## ORIGINATION FORM

### Proposed Revisions to a Standard Plans Index (Please provide all information — Incomplete forms will be returned)

Index Number: 700-041

Index Title: Span Sign Structure

SPAN SIGN ASSEMBLY

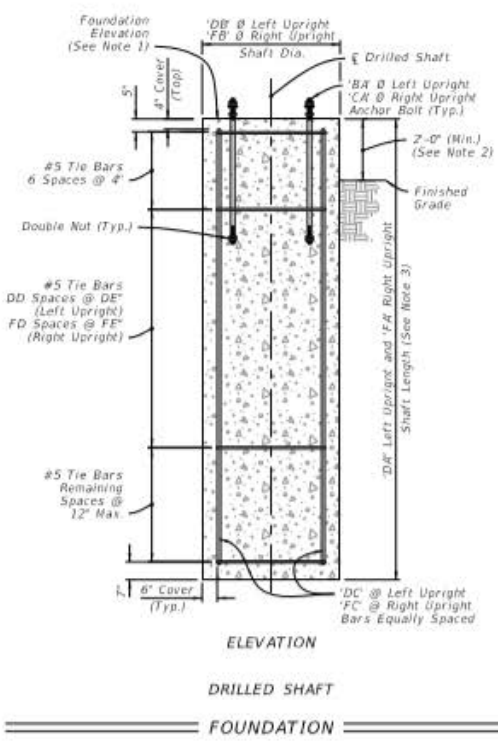
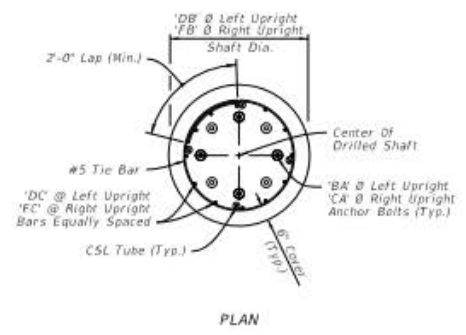
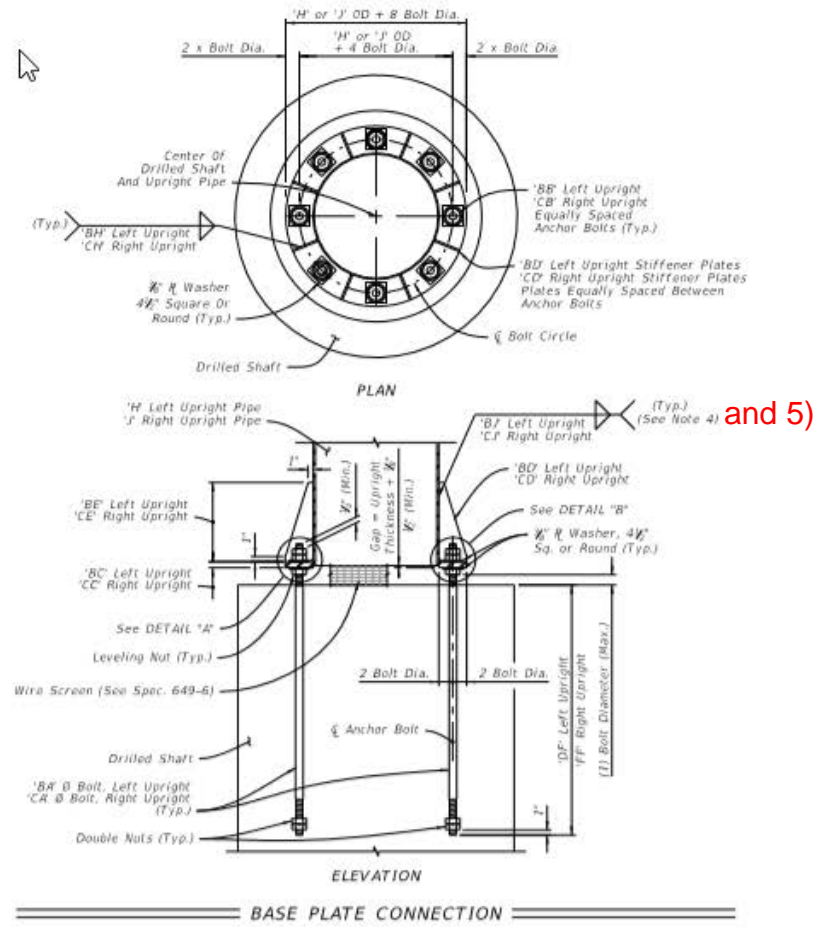
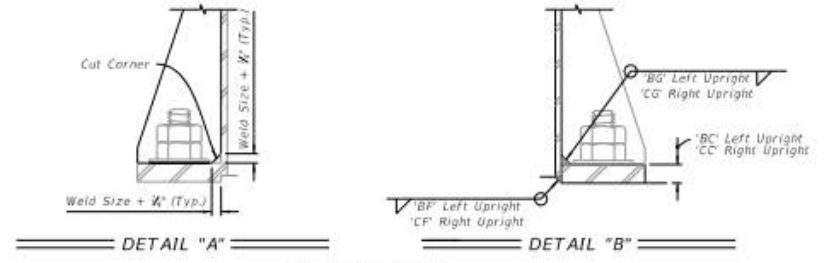
Added Note 5 and reference to the note.

Due to issue with tearing at the top of the stiffeners, adding a requirement for extra testing when poles are greater than 0.5" thick.

and 5)

5. Provide Ultrasonic Testing for Lamellar Tearing when wall thickness exceeds 1/2"
